Subject: Technical Assessment of Extraction Line Magnets for ILC BDS,

in Conjunction with the BDS CCR, July, 2006

Technical assessment of the major differences between the magnets in the 20mrad and 2 mrad crossing angle beamlines, descriptions of problems with the 20/2 case, and assessment of whether changing the crossing angles of the 2 interaction points to both be 14mrad yields any advantages in terms of magnet design, installation, operation and maintenance.

Figure 6

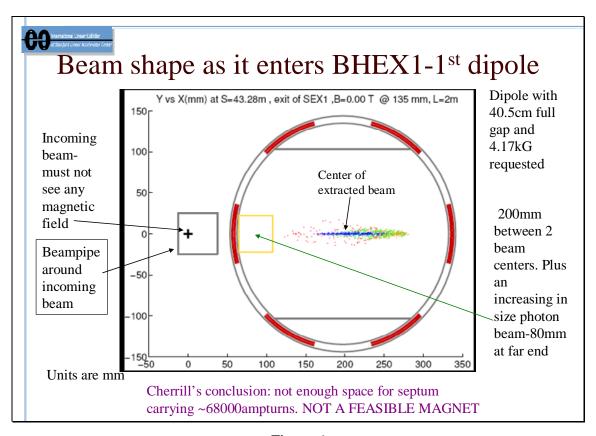
The BHEX1 dipole in the 2mr extraction line has to have a very wide gap in order for the very wide beam not to hit any part of the horizontal bending magnet; at the same time there should be no material sitting in the way of the *beamstrahlung* photons and this severely limits where one can place the electric current (about 68000 ampturns are required) needed to produce the 4.17kG required in the gap. There must be zero field from BHEX1 at the incoming beam. A regular "H" shaped dipole would not work and I couldn't find (in the short time period available to me before the Vancouver LCW06 meeting) a septum dipole layout that could be engineered either. Therefore I declared BHEX1 in the 2mr extraction line to not be feasible.

Figure 7

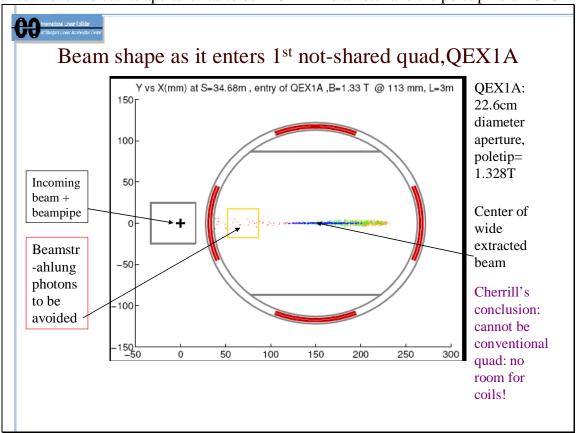
If one designs a conventionally shaped iron-cored quadrupole with a 117mm radius (leaving room for beampipe) and a poletip field of 1.328T and it had all the space it needed, then each coil would need about 63,000 amp turns and the magnet's half-width would be much wider than 120mm. So it is obvious there is not room to put a conventional quadrupole for QEX1A.

So I looked into, what I called a double-Panofsky quad. It would have 2 rectangular shaped openings in its rectangular shaped steel core, one with a quad-shaped field for the extracted beam and the other, smaller, opening for the incoming beam, where there should be ZERO field.

Figure 8

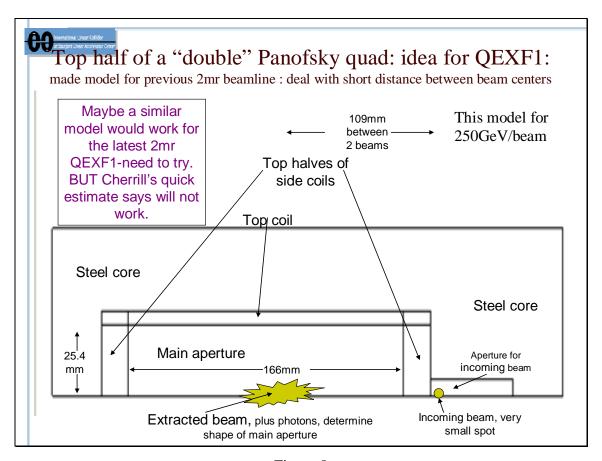
About 17 months ago I did a design of a double Panofsky quad for QEFX1, as it was called back then, the beam optics were a little different from now and I only designed it for 250 GeV beams. That design is shown in Figure 8 below. It appeared to be marginally feasible for the old optics at 250 GeV/beam, but my assessment of such a design for the new optics, with a wider aperture and at 500GeV/beam is that it is not feasible. In the time available to me before the Vancouver LCW06 meeting I had no other ideas for this quadrupole's design. ["Doing a design" involves making a 2D computer model of the magnet using POISSON, choosing a conductor size and designing the cooling circuits to keep the LCW temperature increase below 25°C.]

Figure 9

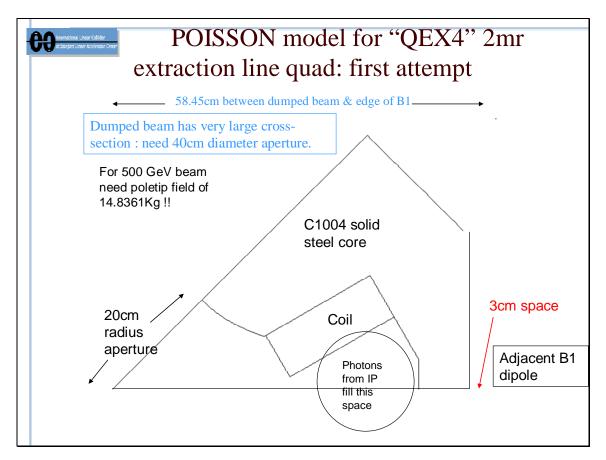
I tried to find a feasible design for the set of quadrupoles called "QEX4" which had the highest gradient requirement of the 12 quads beyond the QEX1A/B mentioned above. Figure 9 below shows one of my efforts, which had to allow the beamstrahlung photons free passage and not touch the low field dipole called "B1" in the adjacent incoming 2mr beamline. When I did this model I thought the photons occupied a circular cross-section, later I found that the shape is more rectangular, see figure 5 above.

Figure 10

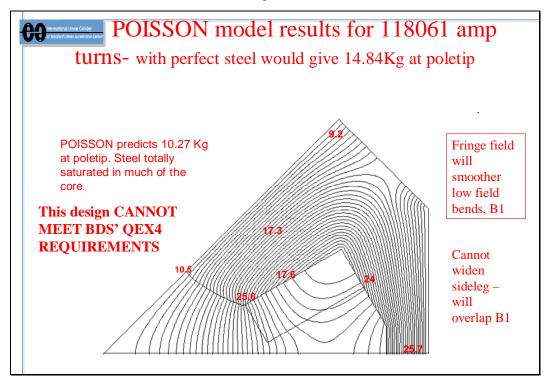
Figure 10 shows the results of a POISSON model of QEX4. The red numbers in the steel core area are the field values at those spots. This model could not achieve the required gradient at 500GeV; it barely achieves the 250GeV gradient.

I tried designs for all the 2mr extraction quads, I determined that 10 were not feasible and 4 were (the last 4 quads, furthest away from the IP). In contrast, ALL the 20mr extraction quadrupoles can be engineered. There are 13 of these room-temperature quads beyond the 3 superconducting quads. The first 5 quads had to be slightly revised in coil shape to fit in the 14mr scenario, the other 8 quads fit on both the 20mr and 14mr beamlines.

Figure 11: Overview of the extracted 2mr beam's Y dimension, leading to very large magnets.

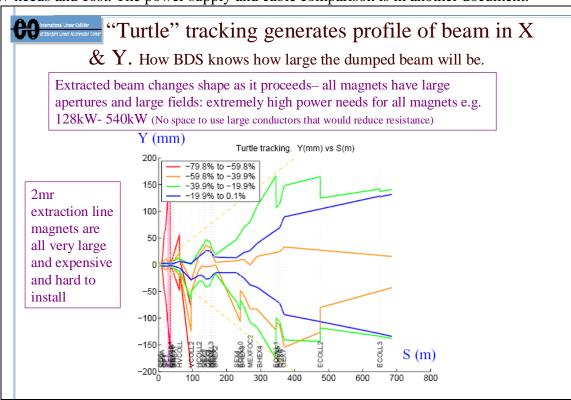
There is very little difference between the 20mr and 2mr magnets in the incoming lines, they have the same requirements and almost the same quantities. The differences are all in the magnets in the extraction lines and that where I will make some general comparisons of size, LCW needs and cost. The power supply and cable comparison is in another document.
